UNTIL SUCH TIME AS THESE DRAWINGS ARE APPROVED BY THE APPROPRIATE REVIEWING AGENCIES, OR ENGINEERING APPROVES THEIR USES DESIGNATED BY WRITTEN AUTHORIZATION.	
PREPARED FOR	ROI PROPERTY GROUP, LLC 2495 RIGDON STREET NAPA, CALIFORNIA (707) 365-6891 BRADY WILLIAMS
	 J.R. ENGINEERING A Westman Company Centennial 303-740-9888 • Colorado Springs 719-583-2583 Fort Collins 970-491-9888 • www.jrengineering.com
BY	DATE
No.	REVISION
H-SCALE	1"=200'
V-SCALE	N/A
DATE	1/2/21
DESIGNED BY	AHC
DRAWN BY	AHC
CHECKED BY	
SADDLEHORN RANCH - FILING 2	
HORIZONTAL CONTROL PLAN	
SHEET	5 OF 40
JOB NO.	25142.04

SADDLEHORN RANCH -
 FILING 2
 STREET IMPROVEMENT PLAN
 AND PROFILE

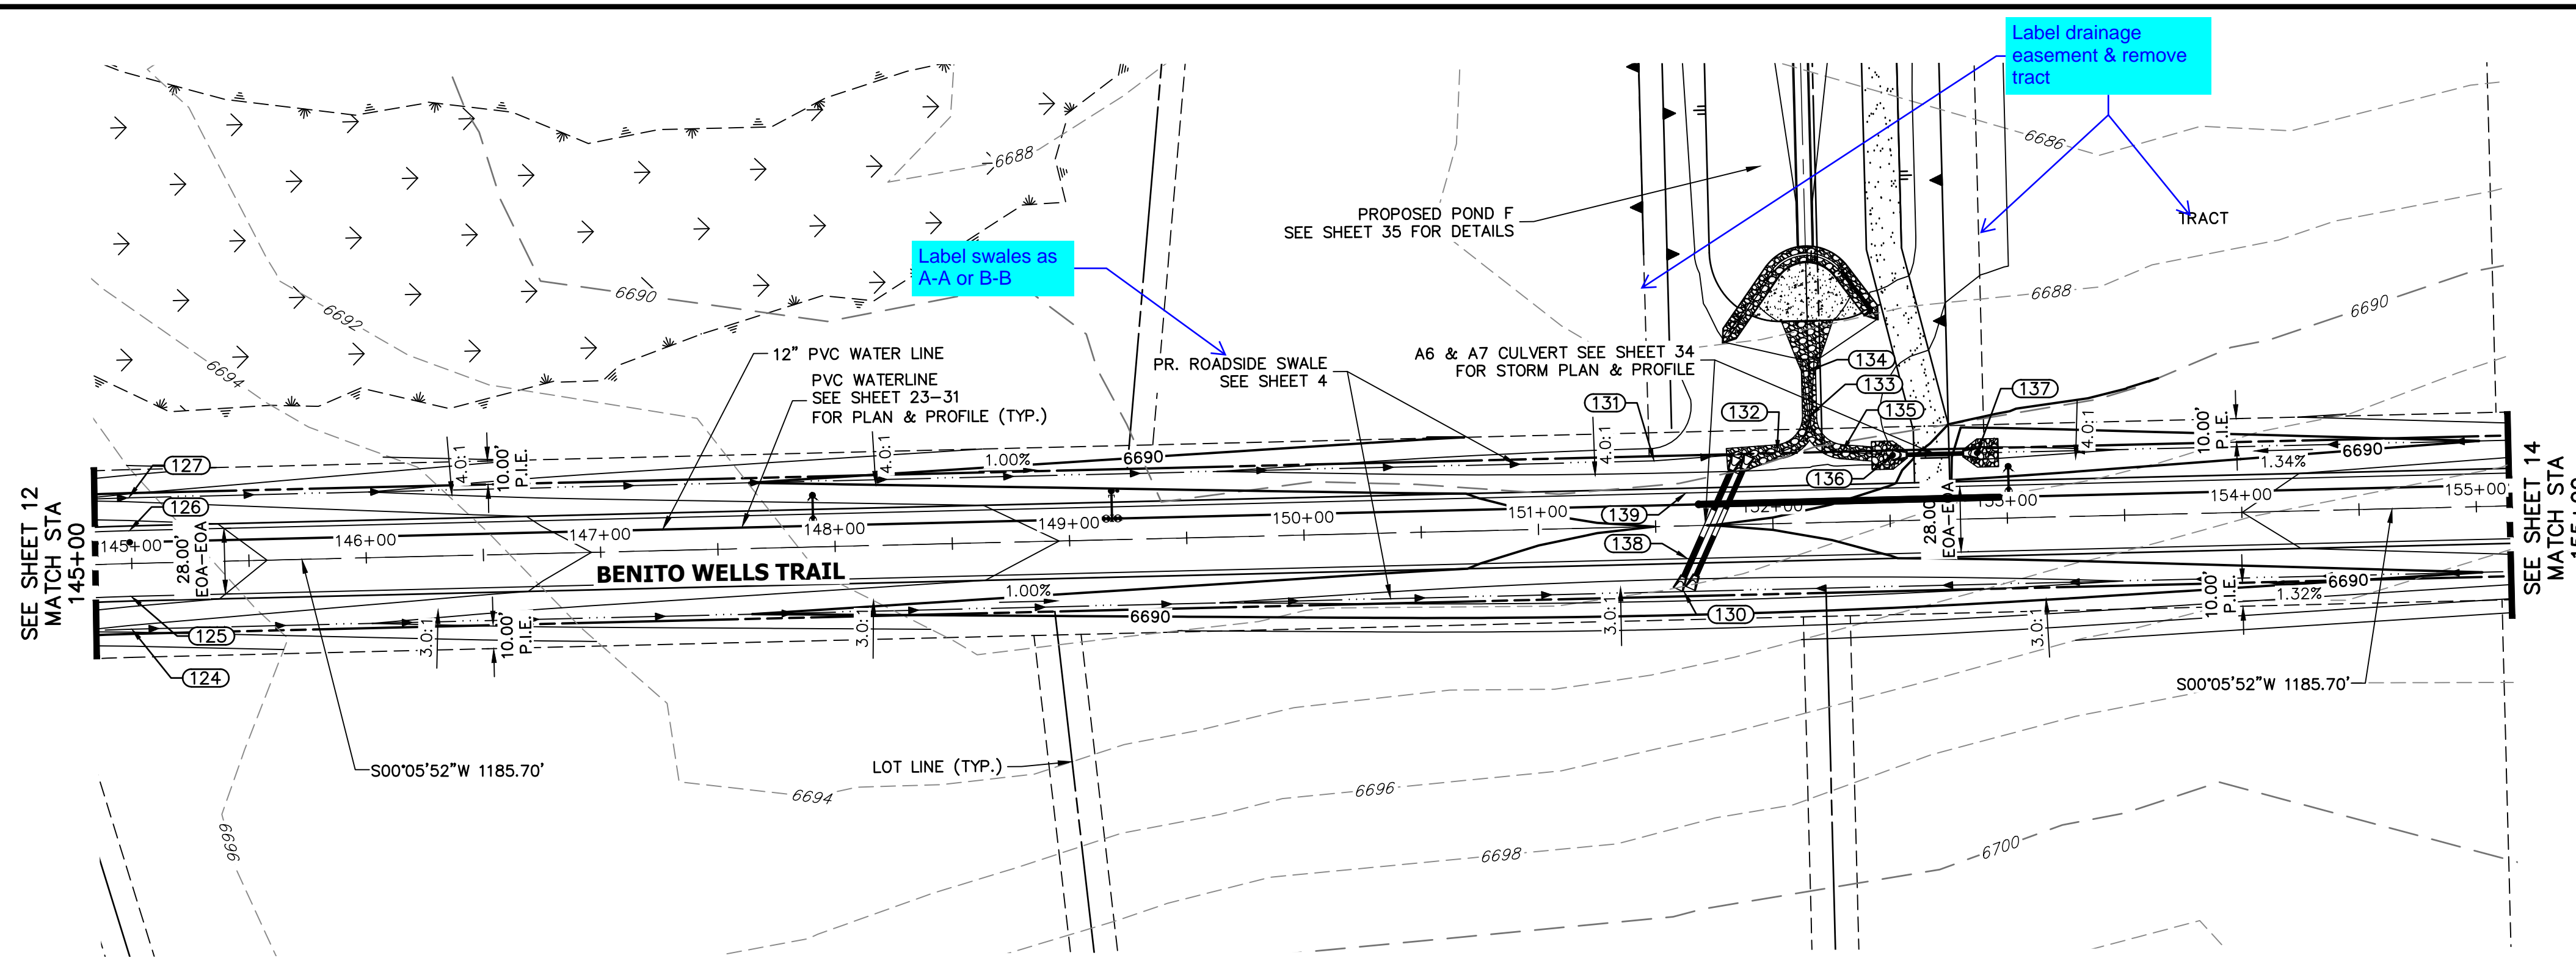
Review 1:
Please also provide coordinates at the intersections or a table or add to a separate horizontal control plan.

Review 2:
Unresolved - Provide coordinates at each CL-CL intersection callout

**CL- ESTACADO PLACE PROFILE
STA 99+50.00 TO 105+30.40**

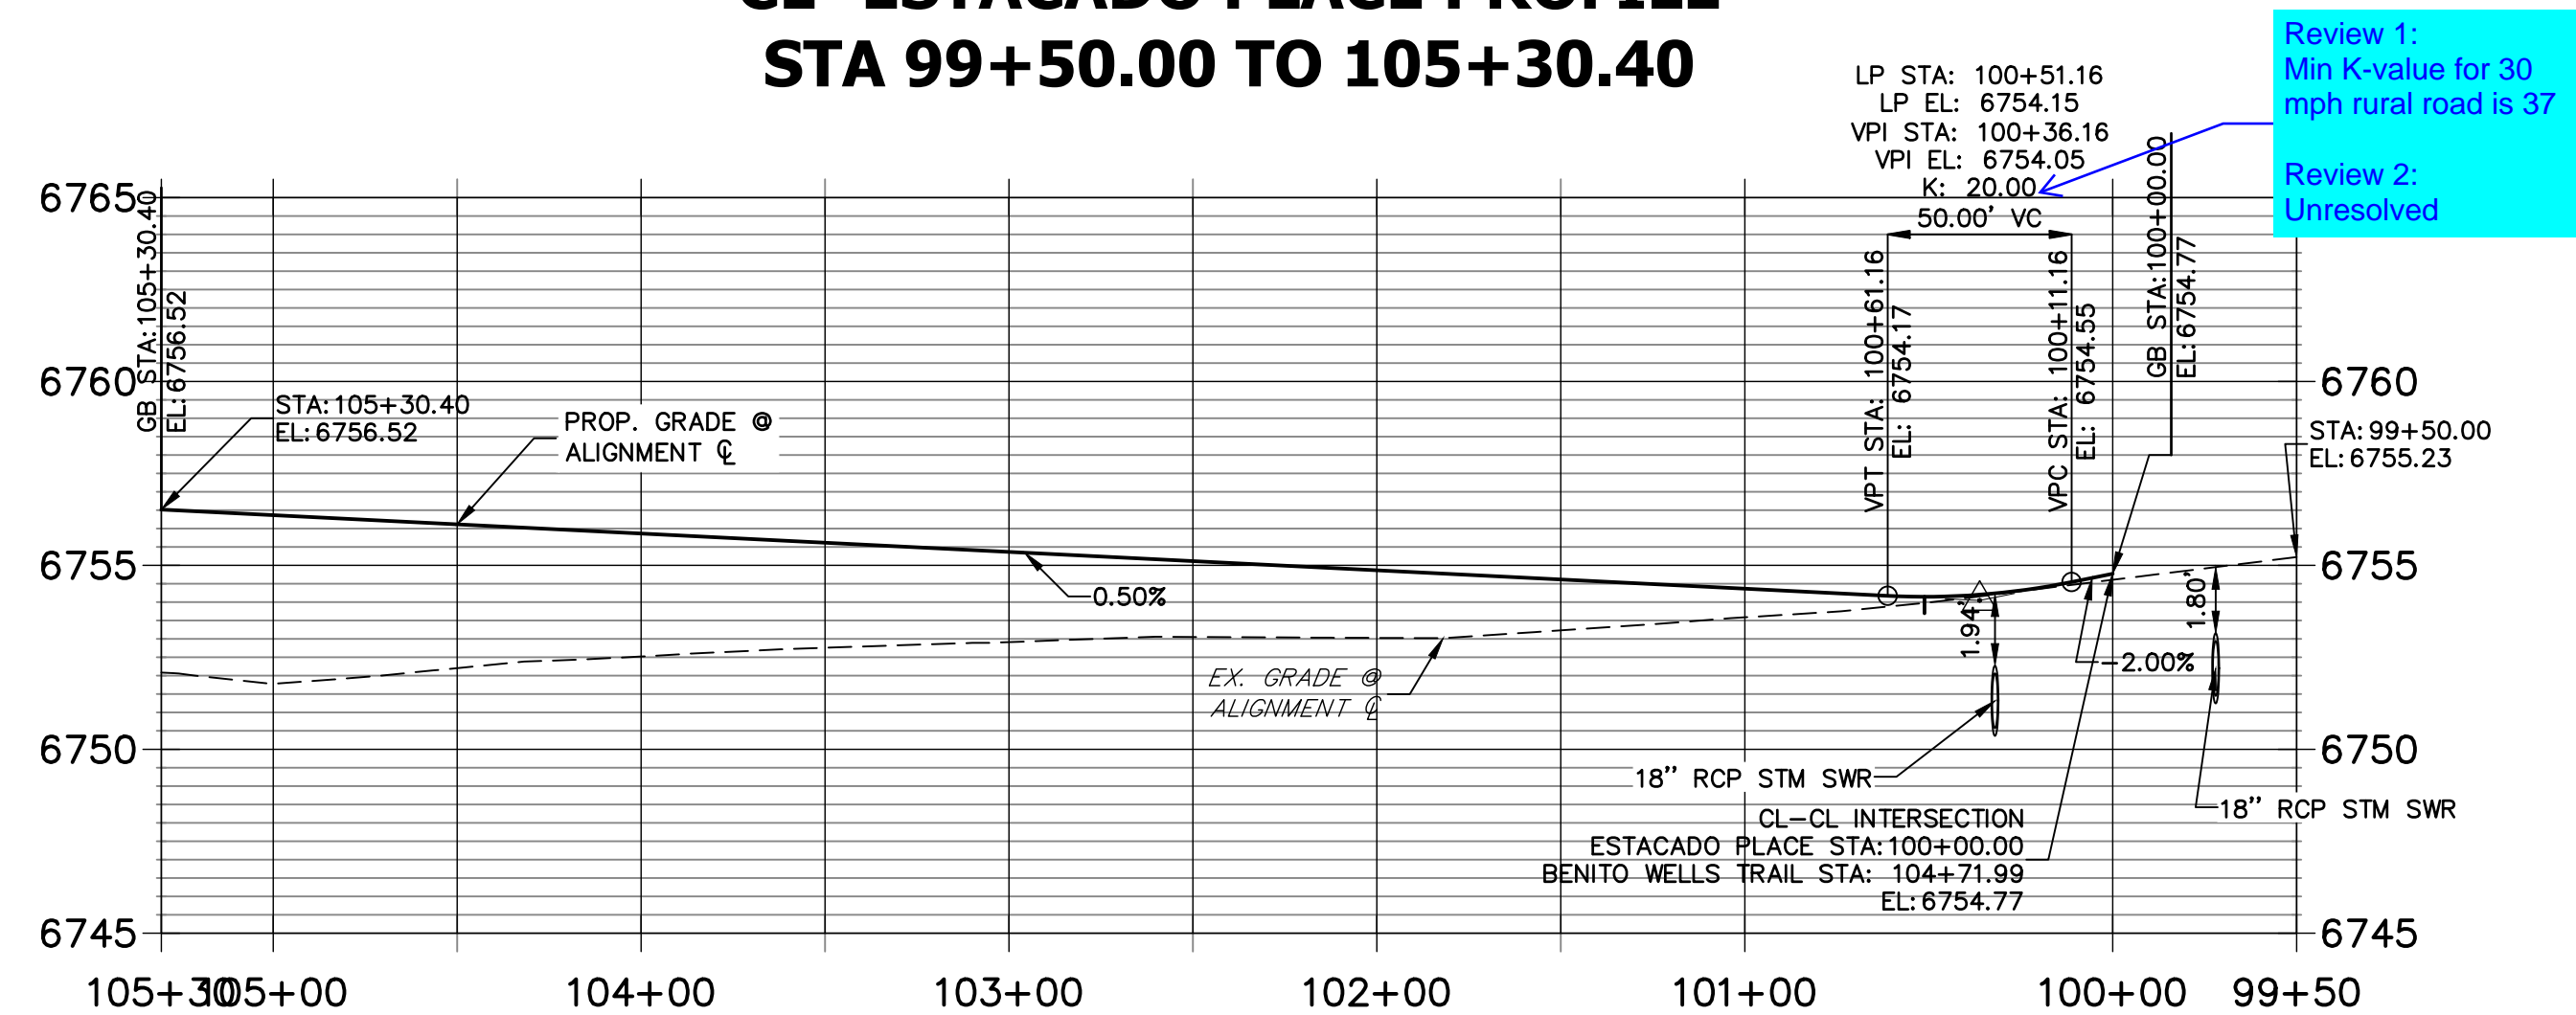
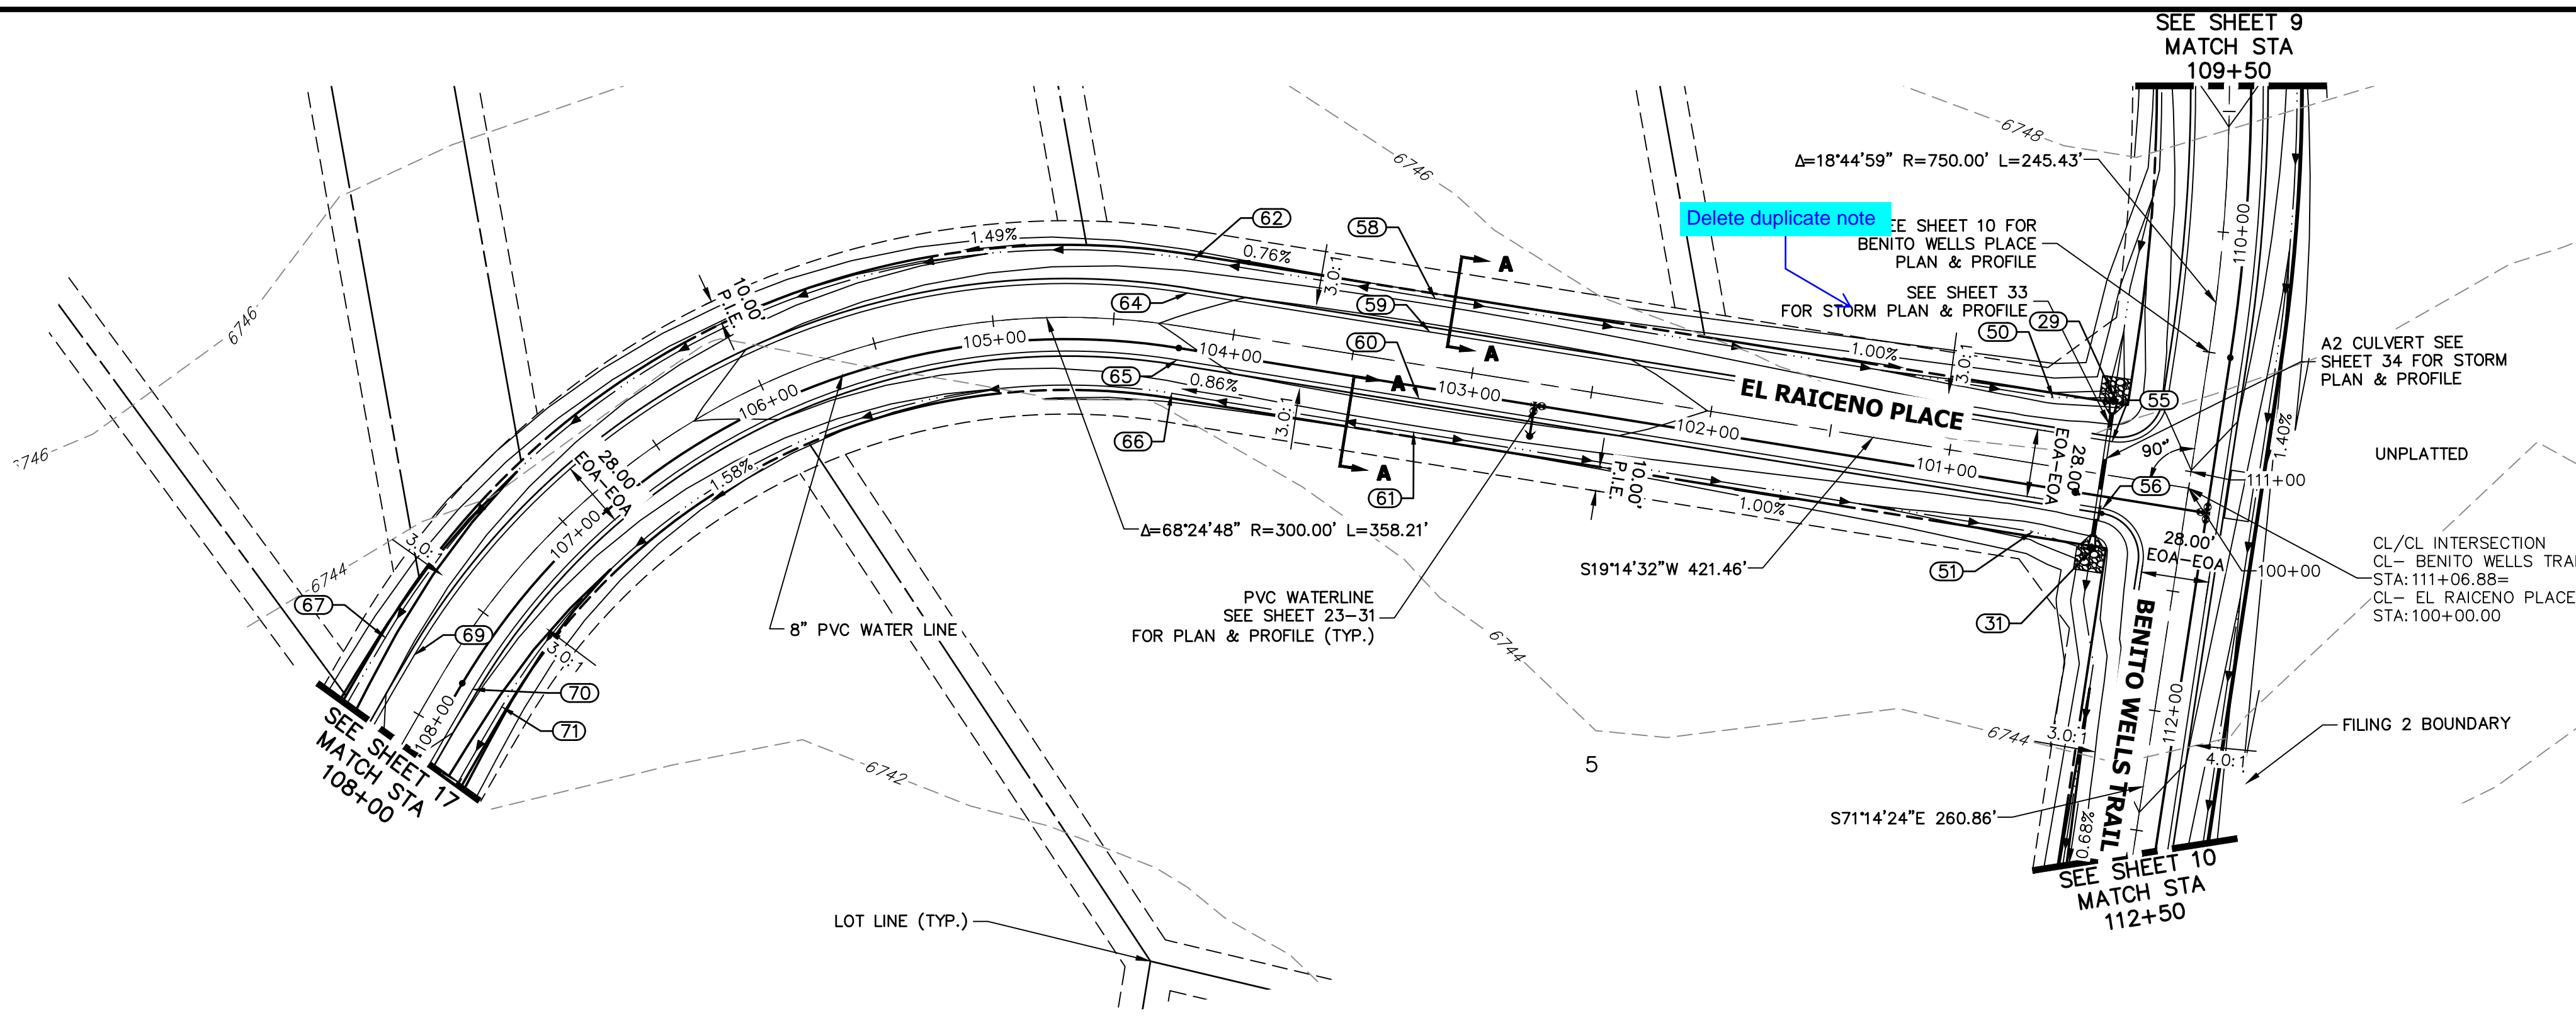
Review 1:
Min K-value for 30
mph rural road is 37

Review 2:
Unresolved
